Chapter 10

10-1 – 12

10-1-12 PC1

FIG. A
 DISTANCE FROM OUTLET TO CFS IS 27 $\frac{1}{2}$ "
 COMPLIANCE WITH 309.2 CANNOT BE ACHIEVED AS A
 RESULT OF THE PROJECTING RANGE

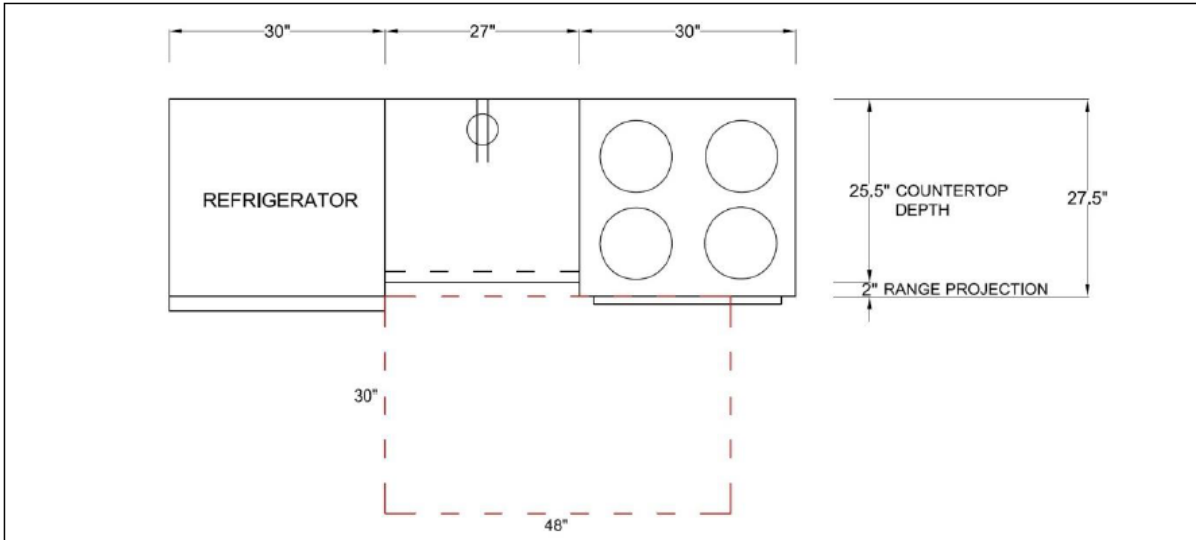
Compliance with proposed language at 1004.9, exceptions 2 and 3 is not possible to achieve if countertops less than 48 inches are located between appliances which project beyond the front edge of the countertop; when they project beyond the front edge of a standard 25½-inch deep countertop, they essentially "push" the clear floor space required by 309.2 (1004.9, Exception 2) too far away from the edge of the countertop rendering the outlet installed at the backsplash unreachable and inaccessible.

For example, if an outlet was located over a 27-inch wide base cabinet (assume 25½-inch deep conventional countertop) flanked on one side by a refrigerator, which projects beyond the countertop edge by 4 inches, and a range on the other side, which projects beyond the front edge of the countertop by 2 inches; then 48-inch long clear floor space positioned for a side approach to the outlet will never be close enough to the edge of the countertop such that the outlet located over it is reachable (see Fig. A). Essentially, accessible reach supported by a side approach in Type B units cannot be achieved unless there is enough space to align the 48-inch long clear floor space such that it is not "pushed" away from the front edge of the countertop by obstructions such as appliances or walls (see Fig. B).

FIG. C

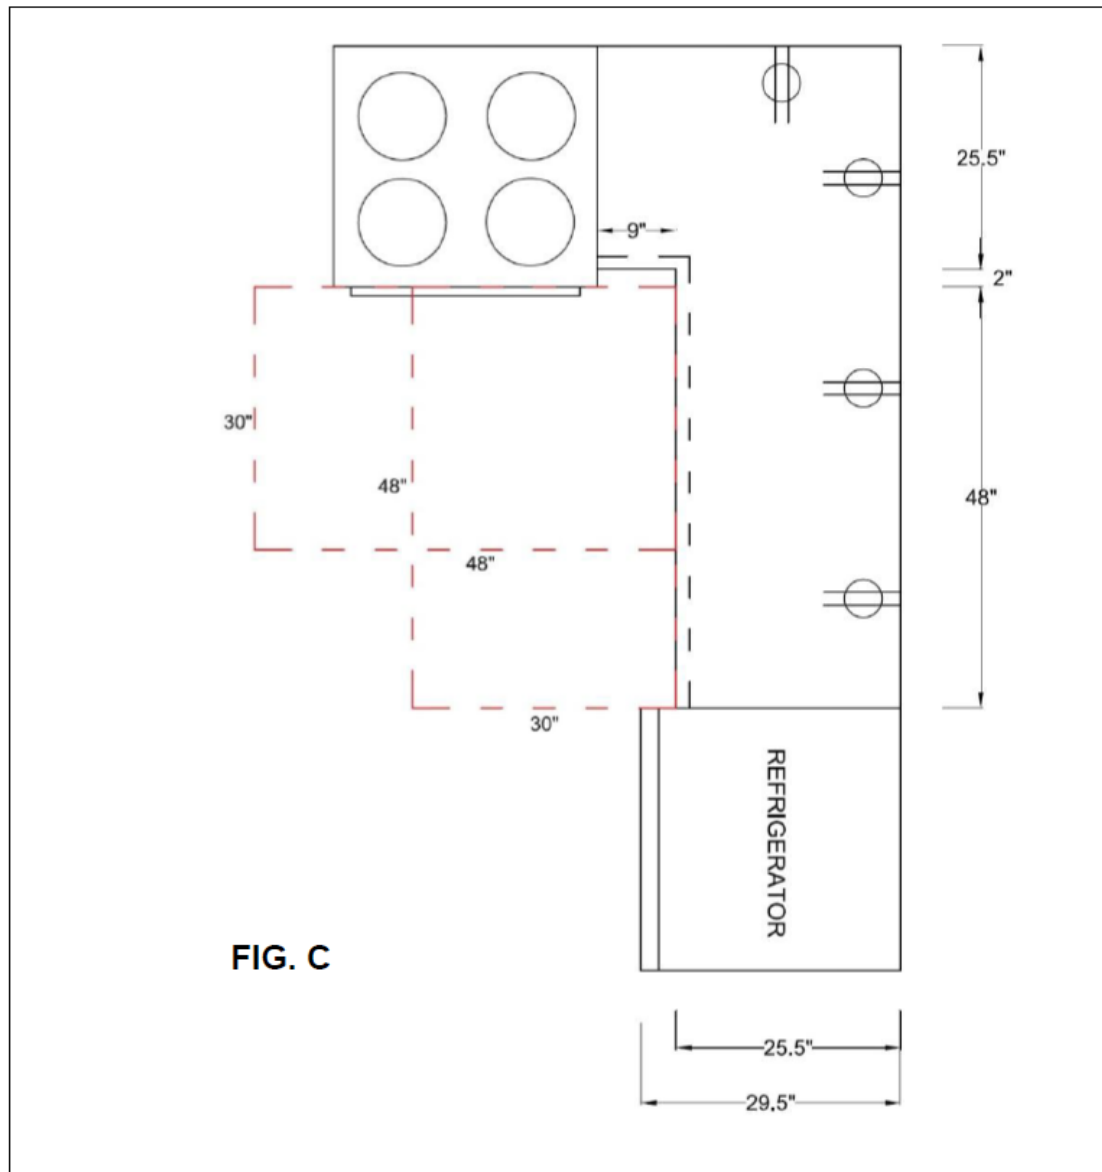
Section 1004.9, Exception 2 certainly is improved in that only one of a number of outlets serving a run of countertop uninterrupted by a sink or appliance is required to be accessible; whereas, before only one was permitted to be inaccessible. However, it does not go far enough. Exception 3 attempts to provide an exception for corner countertops recognizing that the clear floor space cannot be positioned at tight corners flanked by appliances, but again, it doesn't go far enough. Exception 3 contemplates difficulty with achieving compliance only when appliances (range and refrigerator) flank a tight corner. Again, compliance cannot be achieved if there is not enough space on one or both legs of the corner (measured along the front edge of the countertop) to

Moreover, at 1004.9, there is proposed countertop area limit of 7 sq ft., i.e., corner countertops less than 7 sq. ft. in area are exempt from the requirements. For one, the square footage limit does not make sense and should be revisited. When the 48-inch long side of the clear floor space is centered on a conventional 30-inch wide range, that leaves a minimum of 9 inches of countertop to the left = 48 inch centered side approach). If the countertop to the right of the range is a corner countertop, that means the front edge of the countertop must be a minimum of 9 inches before it 'returns.' In order for the 7 sq ft max countertop area to be achieved and compliance over the corner countertops therefore exempt, the 'return' must be no more than 5.03 inches. (see Fig. D). Further, the red crosshatched area is the encroachment into the centered clear floor space at the range by the refrigerator when both appliance project beyond the edge of the countertop and flank a tight inside corner of exactly 7 sq ft in area. This are limit of 7 sq ft. does not work and should be deleted from the current proposed language.
